Form 3160-5 (June 2019)

1. Type of Well  Oil Well  Gas W	/ell Other		8. Well Name and No	). IGOR 33 FED COM/701H	
2. Name of Operator EOG RESOURG	_		9. API Well No. 30-0	125-51723	
	BY 2, HOUSTON, TX 77( 3b. Phone No.	(include area code)	10. Field and Pool or		
JULIANIOS TITI BAGBY SKY LOB	(713) 651-700			33204D; BONE SPRING

Change target formation to Third Bone Spring Sand Ruby.

### **Revised Permit Information 11/09/2023:**

2089' FSL Revised Wellbore A: KB: 3687'

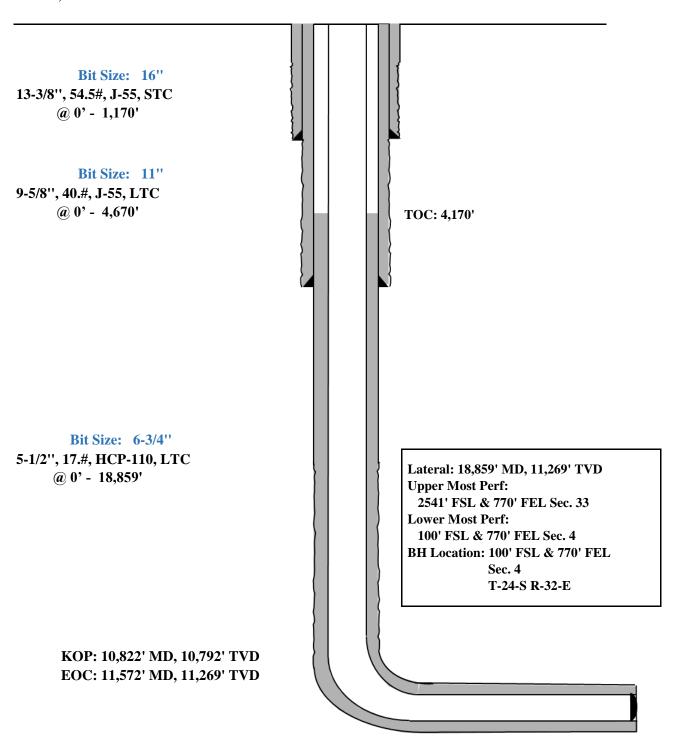
**Casing Program A:**

Hole	Interval MD		Interval TVD		Csg			
Size	From (ft)	To (ft)	From (ft)	To (ft)	OD	Weight	Grade	Conn
16"	0	1,170	0	1,170	13-3/8"	54.5#	J-55	STC
11"	0	4,706	0	4,670	9-5/8"	40#	J-55	LTC
6-3/4"	0	18,859	0	11,269	5-1/2"	17#	HCP-110	LTC

Variance is requested to waive the centralizer requirements for the 9-5/8" casing in the 11" hole size. An expansion additive will be utilized, in the cement slurry, for the entire length of the 11" hole interval to maximize cement bond and zonal isolation.

Variance is also requested to waive any centralizer requirements for the 5-1/2" casing in the 6-3/4" hole size. An expansion additive will be utilized, in the cement slurry, for the entire length of the 6-3/4" hole interval to maximize cement bond and zonal isolation.

2089' Revised Wellbore B: KB: 3687' 474' GL: 3662'

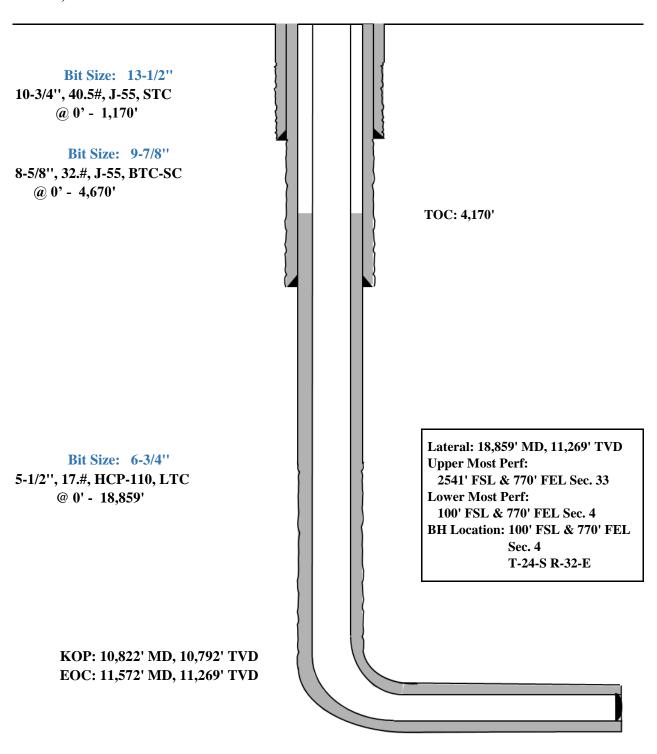
**Casing Program B:**

Hole	<b>Interval MD</b>		Interval TVD		Csg			
Size	From (ft)	To (ft)	From (ft)	To (ft)	OD	Weight	Grade	Conn
13-1/2"	0	1,170	0	1,170	10-3/4"	40.5#	J-55	STC
9-7/8"	0	4,706	0	4,670	8-5/8"	32#	J-55	BTC-SC
6-3/4"	0	18,859	0	11,269	5-1/2"	17#	HCP-110	LTC

Variance is requested to waive the centralizer requirements for the 8-5/8" casing in the 9-7/8" hole size. An expansion additive will be utilized, in the cement slurry, for the entire length of the 9-7/8" hole interval to maximize cement bond and zonal isolation.

Variance is also requested to waive any centralizer requirements for the 5-1/2" casing in the 6-3/4" hole size. An expansion additive will be utilized, in the cement slurry, for the entire length of the 6-3/4" hole interval to maximize cement bond and zonal isolation.
